Modification Recommended Service Note

N8944A - Autoranging System DC Power Supply, 750V, 20A, 5000W, 400 VAC

Serial Numbers: DE14290000 - DE15369999 without manufacturing ID Version "B"

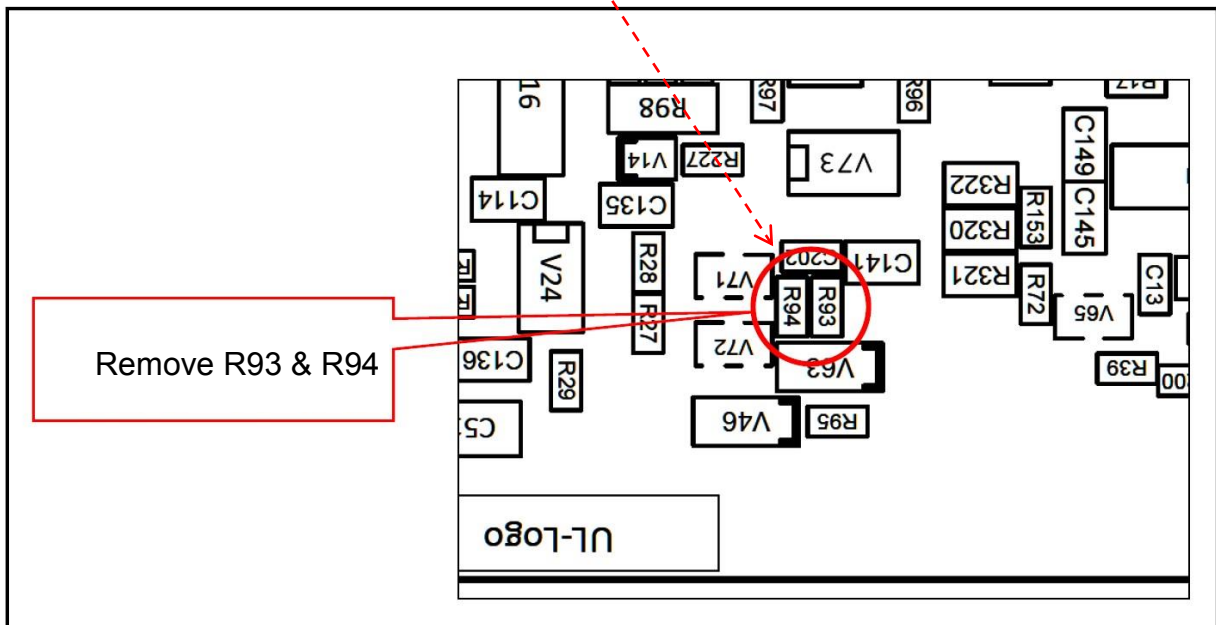
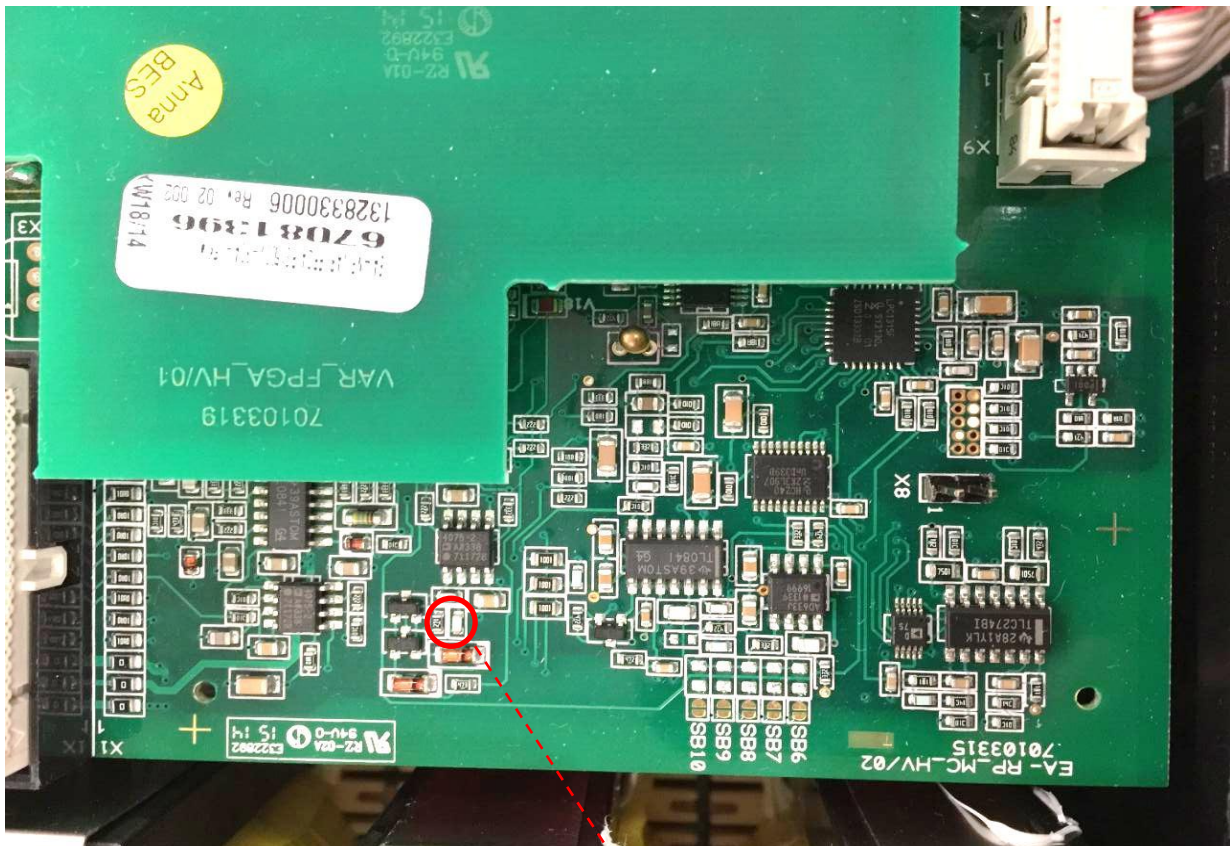
- 1) Remove acMains cable from power source.
- 2) Wait 5 minutes
- 3) Remove top cover from instrument.
- 4) In the 5kW units (viewed from the front of the unit), a small SMT assembly located at the right-rear of instrument will be readily visible (see below):

In the 10kW & 15kW units; although found in the same location, a black plastic cover will have to be removed to gain visibility and access to the SMT assembly. Plastic cover snaps-on and can be removed with a small screwdriver.

Suffix “B” added

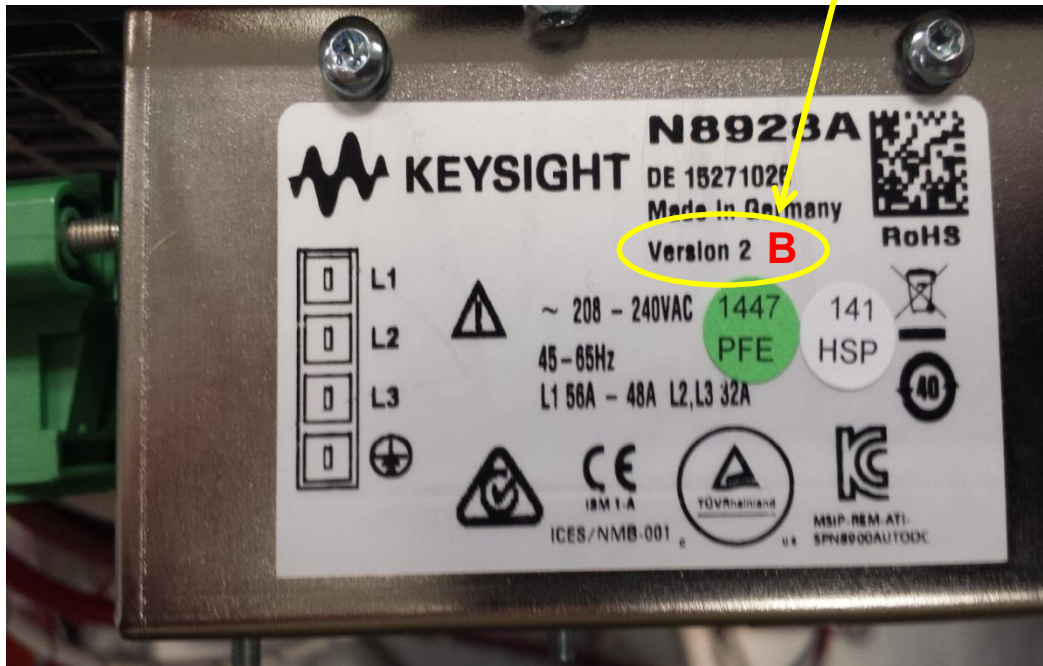
7) On the acMains label, on the rear of the instrument; use an indelible marker, to add the suffix letter “B” after the Version ID. This will assist in the tracking of modified instruments.
